FAQ Number 06-0012 Revision 5

FAQ Title Determining Manual Actions that Require a Change Evaluation during Transition

Plant: Harris Nuclear Plant

**Attachment to FAQ 06-0012 Revision 5
Excerpt from NEI 04-02 Revision 1 with Changes Tracked**

Figure B-4 General Process to Transition Operator Manual Actions

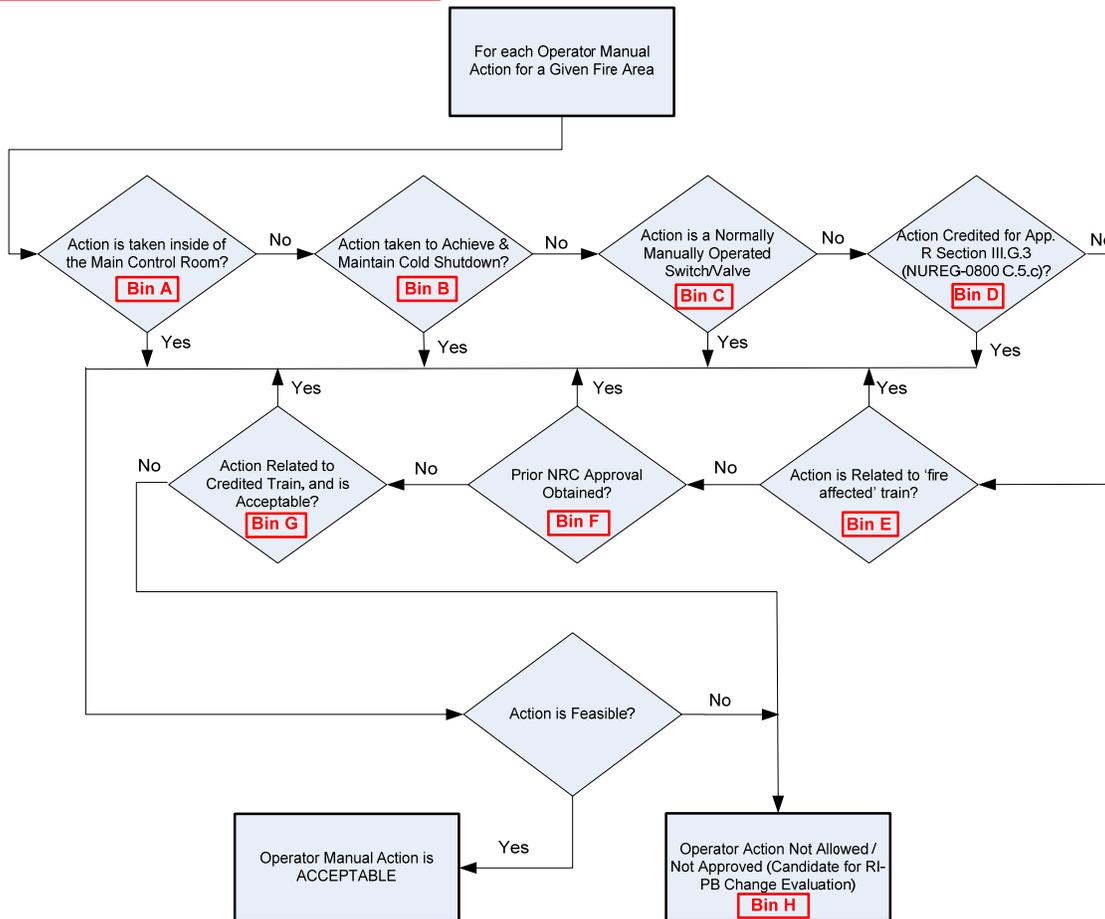
Figure B-4 depicts this general process for determining whether a transitioning operator manual action to NFPA 805 recovery action requires a change evaluation. The ‘bin’ identifiers are for ease of reference.

Operator manual actions that are allowed and/or have been previously reviewed and approved by the NRC (as documented in an approved exemption/deviation/safety evaluation report) can be transitioned without the need to use the change evaluation process. In some cases the previous approval may not be obvious, yet should be allowed. Examples of allowed operator manual actions are include:

- Operator manual operation from the control room or emergency control station(s) [Bin A]
- Repairs or operator manual actions credited either for transitioning to or maintaining cold shutdown equipment [Bin B]
- Manual operation of normally operated manual switches and valves where separation/protection is provided for redundant safe-shutdown trains in accordance with Section III.G.1 or III.G.2 of 10 CFR 50, Appendix R (or applicable sections of NUREG-0800) [Bin C]

Figure B-6 Allowed Operator Manual Action in Fire Area Meeting 10 CFR 50, Appendix R, Section III.G.2 Compliant – Operator Manual Action for Fire Affected Train

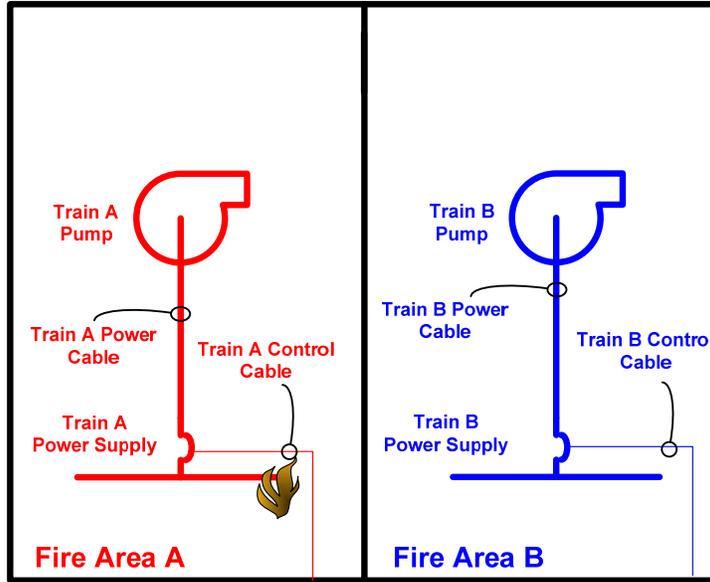
- operation of equipment for which cables are located in fire areas that meet Section III.G.1 of Appendix R to 10 CFR Part 50, by having redundant cables and equipment in a completely different fire area”
- Operation of fire affected equipment for fire areas that meet the protection requirements of Section III.G.2 of 10 CFR 50, Appendix R (or applicable sections of NUREG-0800) for redundant trains. See Figure B-6. [Bin E]

RIS 2006-10 states: “As discussed during a March 1, 2006, public meeting, if one of the redundant trains in the same fire area is free of fire damage by one of the specified means in paragraph III.G.2, then the use of operator manual actions, or other means necessary, to mitigate fire-induced operation or maloperation to the second train may be considered in accordance with the licensee’s fire protection program and license condition since paragraph III.G.2 has been satisfied.”

Fire Area B meets the separation criteria of 10 CFR 50 Appendix R Section III.G.2.a. A postulated fire in Fire Area A could result in the spurious starting of the non-credited Train A pump, which can be mitigated by an operator manual action to de-energize the Train A Power Supply to stop Pump A. This is functionally equivalent to Case in Figure B-5.

Figure B-5 Allowed Operator Manual Action in Fire Area Meeting 10 CFR 50, Appendix R, Section III.G.1 Separation Criteria

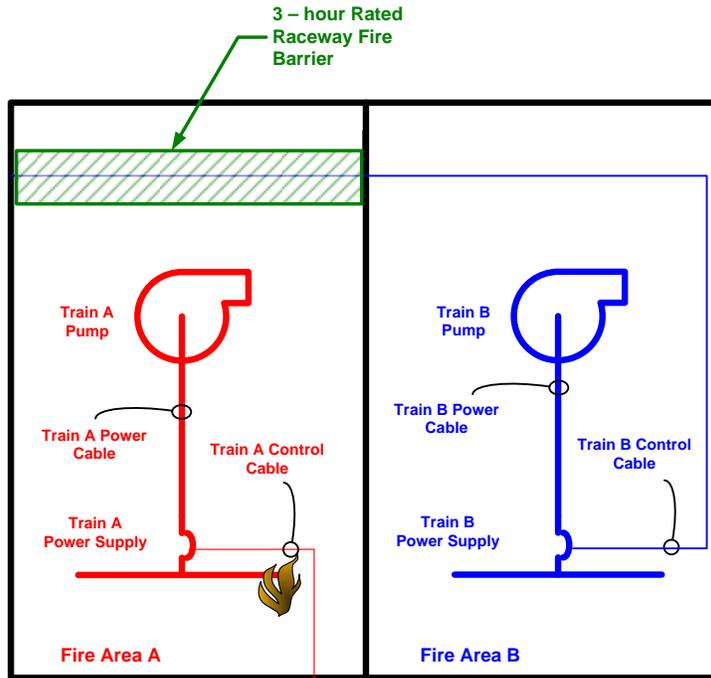
- ~~▪ Operation of equipment for which cables and equipment for the redundant safe shutdown train are located in separate fire areas thus meeting Section III.G.1 of Appendix R to 10 CFR Part 50;~~
- ~~▪ Manual operation of normally operated manual switches and valves where III.G.1 separation is provided for redundant safe shutdown trains~~
- Operation of fire affected equipment for fire areas that meet the separation requirements of Section III.G.1 of 10 CFR Part 50, Appendix R (or applicable sections of NUREG-0800). See Figure B-5. [Bin E]

Fire Area A and B meet the separation criteria of 10 CFR 50 Appendix R Section III.G.1. A postulated fire in Fire Area A could result in the spurious starting of the Train A pump, which can be mitigated by an operator manual action to de-energize the Train A Power Supply to stop Pump A.

Figure B-7 Allowed Operator Manual Action – In Credited Success Path – Common Tank Suction

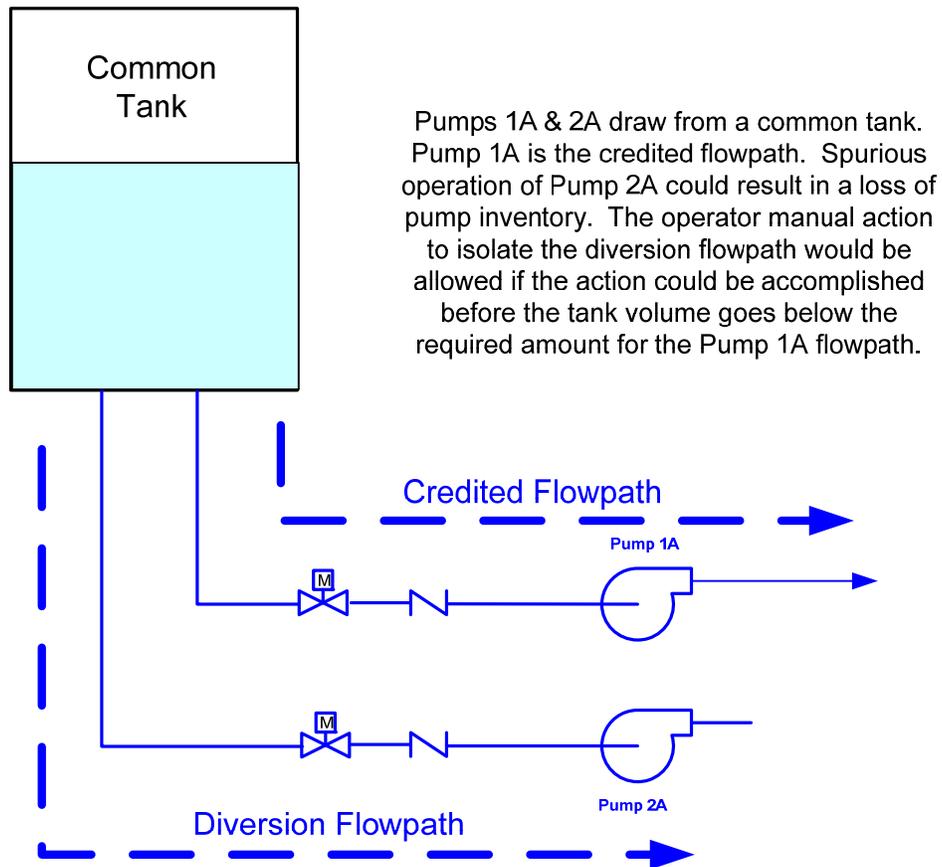
A special case of “fire affected train” exists where two redundant trains have components/cables in a given fire area, and both trains take suction from a common tank. In this case, a manual action would be allowed (and no change evaluation would be required) to secure the fire affected train, since the credited train is protected (meets III.G.2 requirements) even though the manual action would need to be accomplished before the common tank level decreased to the point where operation of the credited train would be affected. This is acceptable since the common point in the system is the tank, which is still free of fire damage (Figure B-7). This example was discussed in the June 9, 2006 public meeting. (ML061980016)

Figure B-8 Operator Manual Action – In Credited Success Path – Auxiliary Feedwater Flow Diversion [not allowed per NRC Ref. ML072820168]

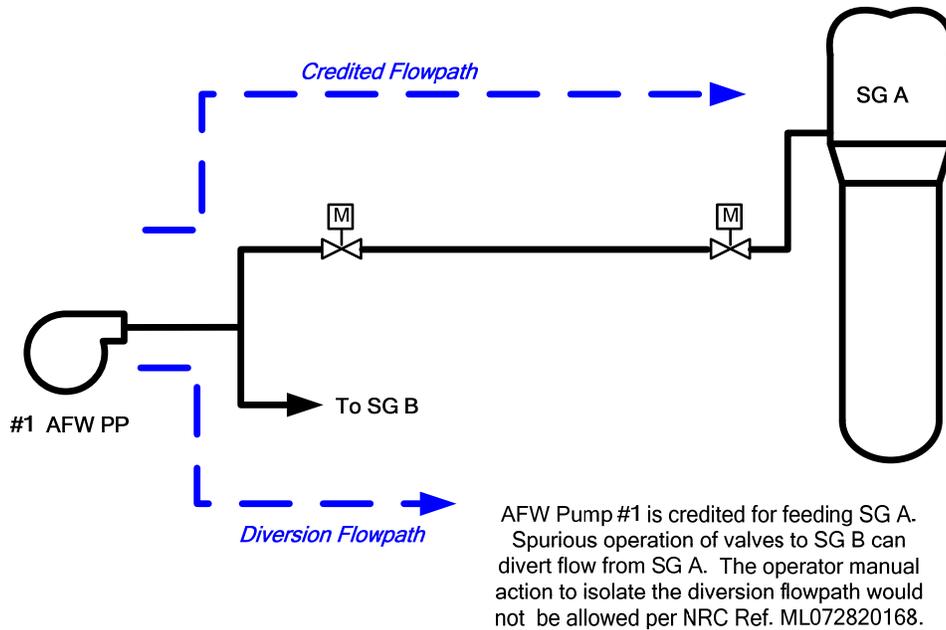
An example where operator manual action to address spurious actuations that affect the credited safe shutdown success path would not be allowed is the case where the credited function is to inject water to one of the Steam Generators (reactor) and a spurious actuation causes a diversion from the credited flow path. Even though the minimum required injection flow can be maintained and the operator manual action can be accomplished prior to the function being disabled, the operator manual action

is not allowed and a change evaluation would be required since the credited train is not free of fire damage (the diversion of flow must be terminated at some point or the credited safe shutdown path will not be successful). (Figure B-8). An example of this configuration is BWR example 3 of the June 9, 2006 public meeting (ML061980016). This clarification of the ‘credited train not being free of fire damage’ was provided by the NRC on September 20, 2007. (ML072820168)
